CITY COUNCIL STAFF REPORT
Meeting Date December 12, 2022

AGENDA ITEM: Multifamily Residential Project, 3090 Southlawn Drive North
 a. Preliminary Plat and Final Plat Resolution
 b. Wetland Buffer Variance Resolution
 c. Design Review Resolution

Enclave Development proposes constructing a 241-unit, four-story, market-rate apartment building on the property at 3090 Southlawn Drive. To move forward with this project, the applicant requests city council approval of a preliminary and final plat, wetland buffer variance, and design review.

EXHIBIT 3. WETLAND BUFFER PROPOSED CONDITIONS

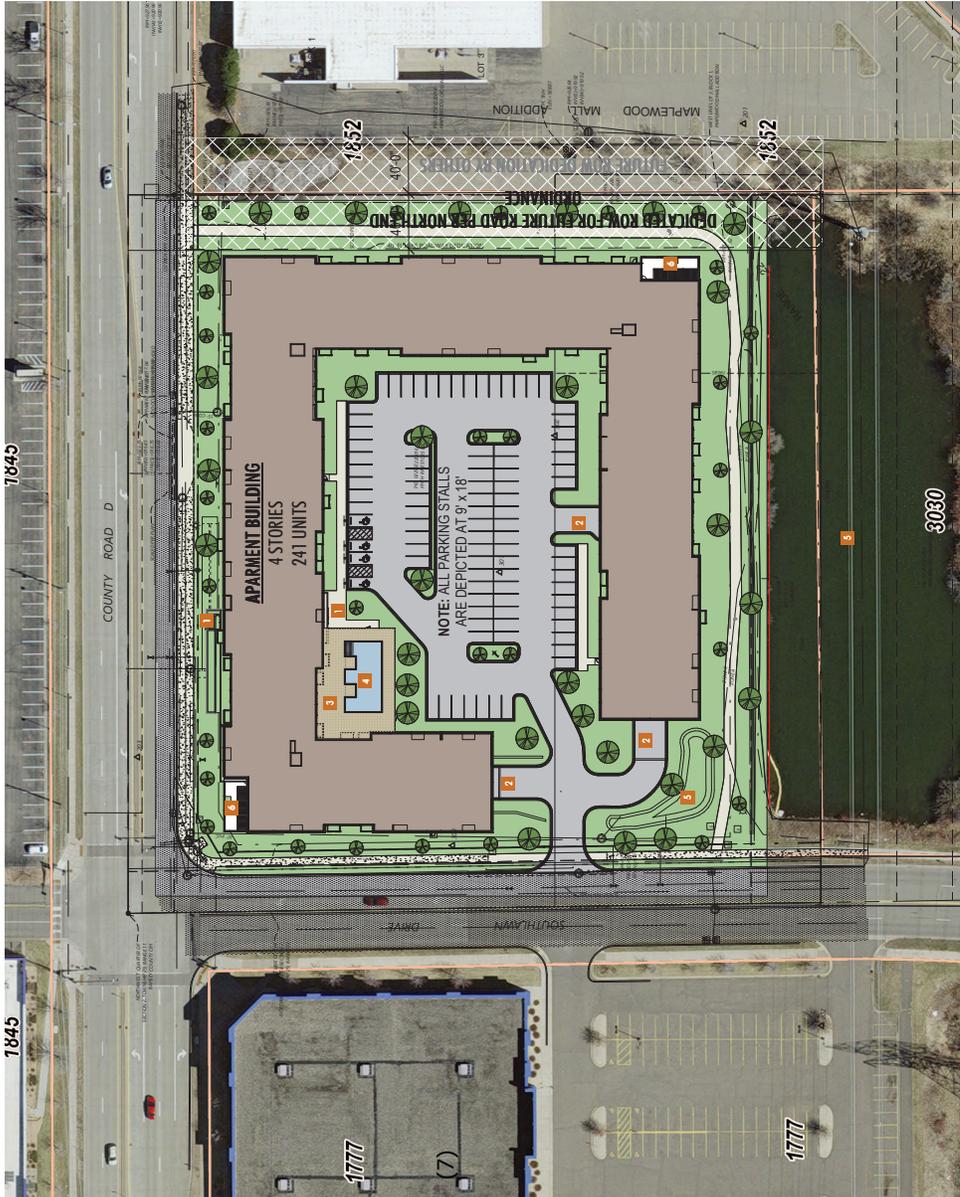
The wetland buffer changes are an improvement to the initial submittal. Environmental staff is recommending two additional mitigation strategies:

- (1) Extend the native plugs and mesic prairie seed mix the full 15 feet from the retaining wall to the 5-foot mowed strip along the sidewalk.
- (2) Submit detailed bench plans showing the locations, style, installation, and hard surface landscape plan to include boulders or rocks and native plants along the south side of the benches.

- a) Native Buffer: Extension of the proposed 10-foot wide wetland buffer native plant plugs and seed mix to within 5 feet of the sidewalk, for an approximate native buffer of 15 feet.

- b) Planting Table: Update the wetland buffer native planting table to identify the quantity of each native plant plug species.
 - c) Bench Plans: Detailed bench plans showing the locations, style, installation, and hard surface landscape plan to include boulders or rocks and native plants along the south side of the benches.
